TECHNICAL TIPS

- OCTOBER 1992 -

#32

TECHNICAL TIPS # 32
OCTOBER 1992

CAM/PINION GEAR COLOR CODE CHART

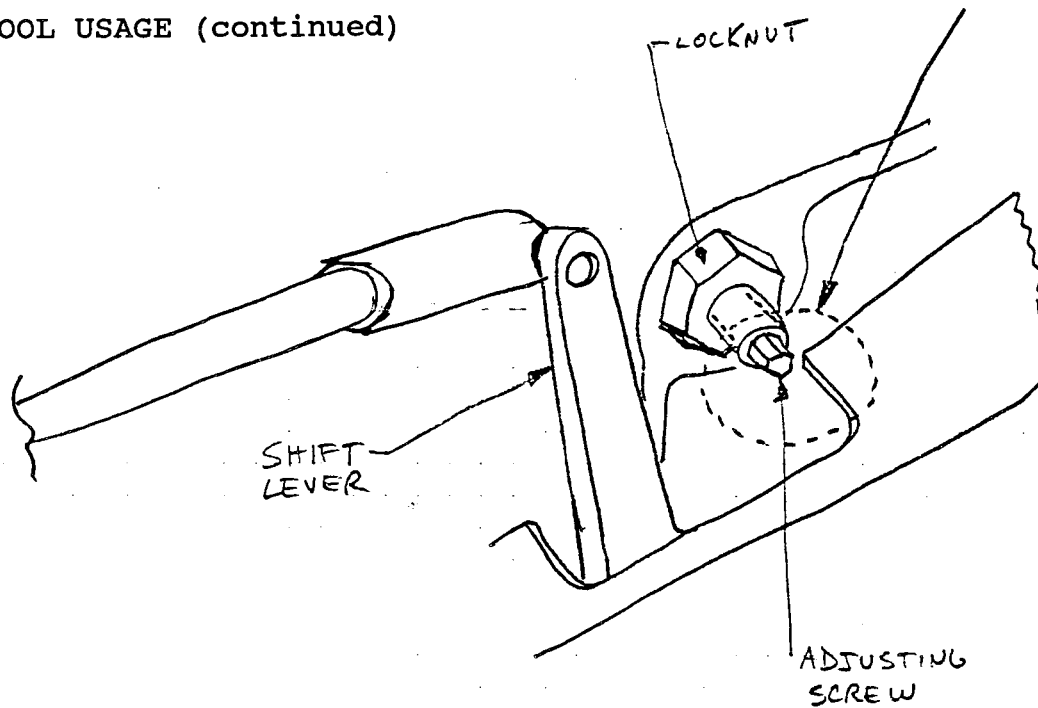
Page 3-43 of the 1993 FX and Dyna Glide Service Manuals incorrectly list the part numbers for the pinion gears. Please note these corrections for your dealership's Service Manuals.

COLOR CODE	PINION GEAR	CAM GEAR	
<i>NOTE</i>		<i>(matched sets)</i>	
<ul style="list-style-type: none"> • Use 0.108 in. pins to measure. • Cam gears have two grooves on face. 			
	Part no.	Size (in.)	Size (in.)
ORANGE	24040-90	1.4853/1.4850	<i>NOTE</i> 2.7472/2.7476
WHITE	24041-90	1.4849/1.4846	<i>Check parts</i> 2.7477/2.7481
YELLOW	24042-90	1.4845/1.4842	<i>catalog for</i> 2.7482/2.7486
RED	24043-90	1.4841/1.4838	<i>cam and pin-</i> 2.7487/2.7491
BLUE	24044-90	1.4837/1.4834	<i>ion sets part</i> 2.7492/2.7496
GREEN	24045-90	1.4833/1.4830	<i>numbers.</i> 2.7497/2.7501
BLACK	24046-90	1.4829/1.4826	2.7502/2.7506
